Calpine Enhanced Geothermal Systems Project

Final Environmental Assessment

June 2010

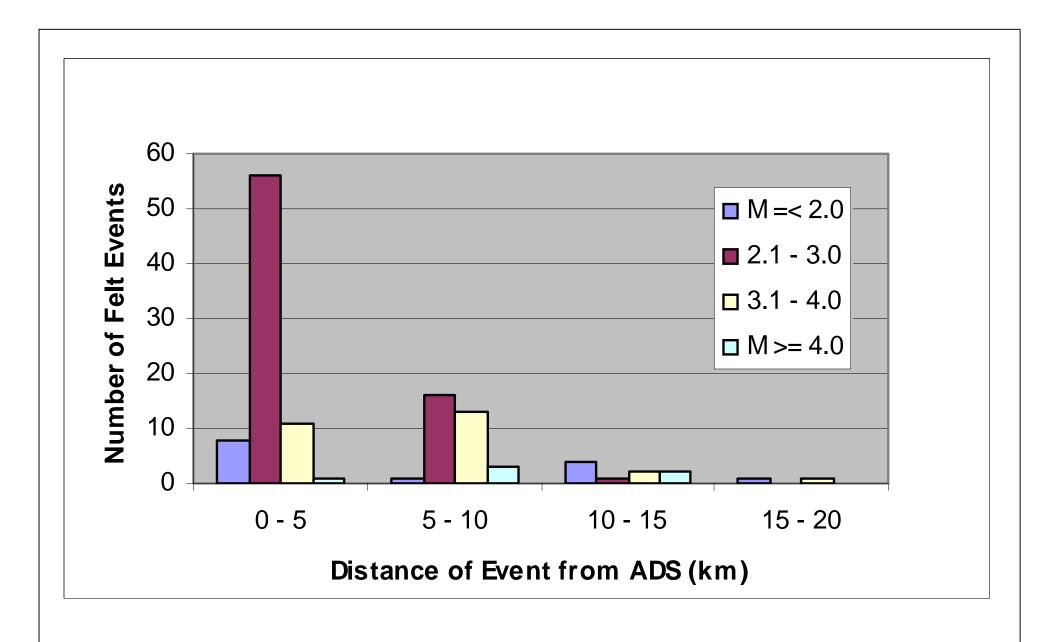
4. No cut-off magnitude or intensity levels have been specified as safety and nuisance mitigations for this project. We recognize that the geographical location of the project seems sufficiently remote from residential communities that destructive and heavy nuisance impacts would not be expected, but we believe that it is not unreasonable to request that if a project-related seismic event of M 4.0 or greater occurs, or a Mercalli intensity VI (that is, 9.2% g to less than 18% g) is recorded at either the Cobb or Anderson Springs ground motion stations, a temporary shutdown be required pending study of the possible causes of the event, and that there be complete shutdown of the project if higher Richter (above M 4.5) or Modified Mercalli readings of higher (18% g+) occur.

As stated on page 5-2 of the induced seismicity report included as Appendix I to the EA, the highest peak horizontal ground acceleration recorded to date on the Calpine strong motion instrument is 0.21 g at a distance of 2.0 km from ADSP. No damage was reported in that event according to the hotline calls and so no intensities in the "destructive" range have been observed to date.

Figures 2 and 3 show the PGA values recorded at ADSP and COB, respectively, from March 2003 through August 2008. Figure 2 shows that at distances beyond 10 km, only the larger events ($\mathbf{M} \geq 3.5$) record PGA values above 0.01 g (1% g) and no event had a PGA exceeding 0.10 g (10% g). Note that ADSP may have unusual site effects at the instrument site compared to the rest of the community, i.e., the ground motions are biased high. Anderson Springs is located about 14 km from the Prati State 31 and 32 wells. Figure 3 shows that no events have recorded a PGA higher than 0.03 g (3% g) at a distance greater than 8 km. Cobb is situated at about 10 km from the Prati State 31 and 32 wells. Although it is extremely difficult to estimate, it is not expected that earthquakes much larger than \mathbf{M} 3 will result from the EGS operations at Prati State 31 and 32 due to the low pumping rates and thus it is unlikely that a PGA, such as 0.18 g, will be observed in Cobb.
